**CITY OF TEMPE
DEVELOPMENT REVIEW COMMISSION**

**Meeting Date: 09/14/2021
Agenda Item: 3**

ACTION: Request a Development Plan Review for a new +/- 2,626 square-foot building for STARBUCKS AT SOUTHERN PALMS, located at 3206 South McClintock Road. The applicant is Archicon Architecture & Interiors, L.C.

DEVELOPMENT PROJECT FILE
for
STARBUCKS AT SOUTHERN PALMS
(PL210165)

SHEET DESCRIPTION
BUILDING SECTION

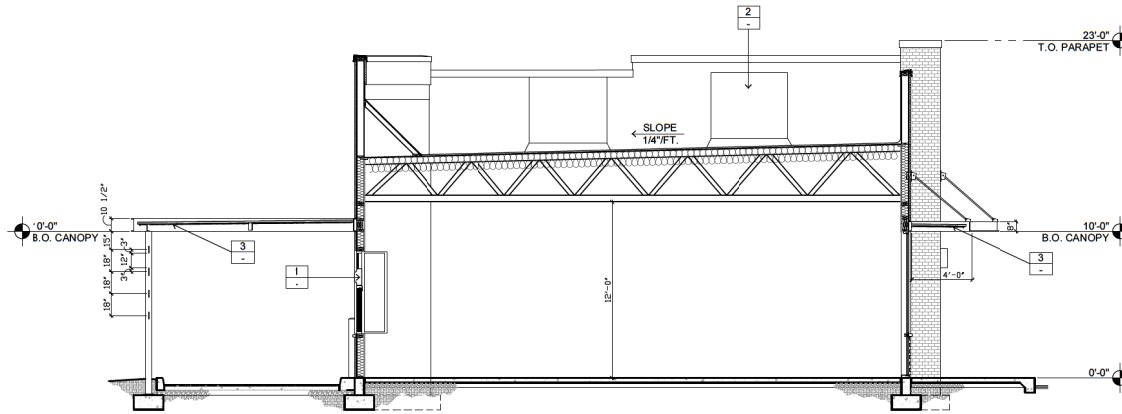
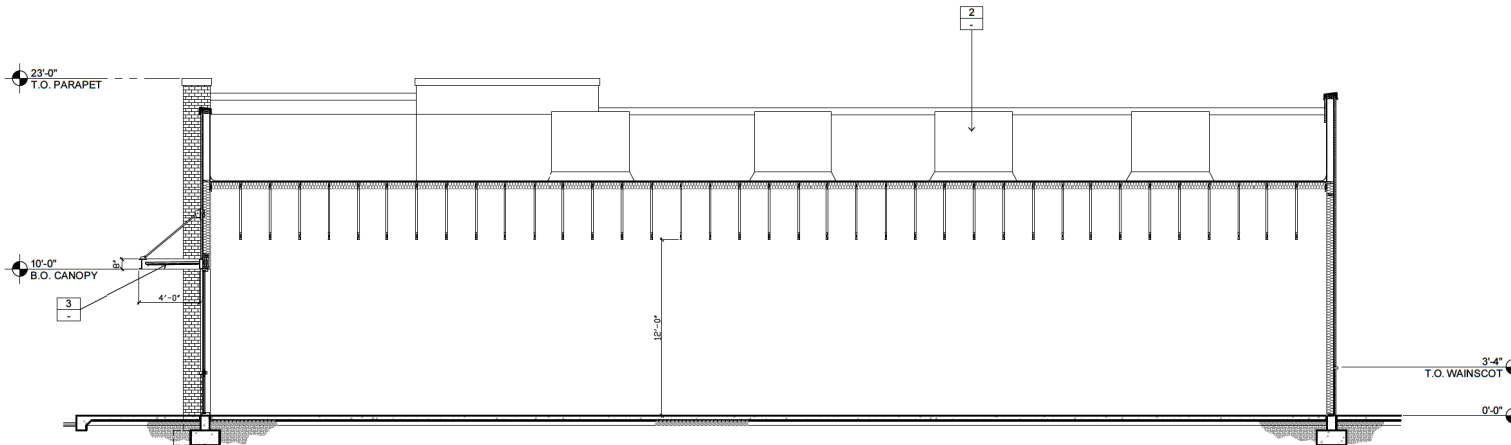
NOTE:
PER CITY COMMENTS SPR20079_MARKUP_072821
- BUILDING SECTION MAKES IT APPEAR AS THOUGH
ROOF TOP EQUIPMENT WILL BE FULLY SCREENED*
PER THE ELEVATIONS THIS EQUIPMENT IS NEAR
FULLY SCREENED. SECTION IS SHOWING EQUIPMENT
AGAINST SCREEN WALL IN THE FOREGROUND FOR
REPRESENTATION PURPOSES.
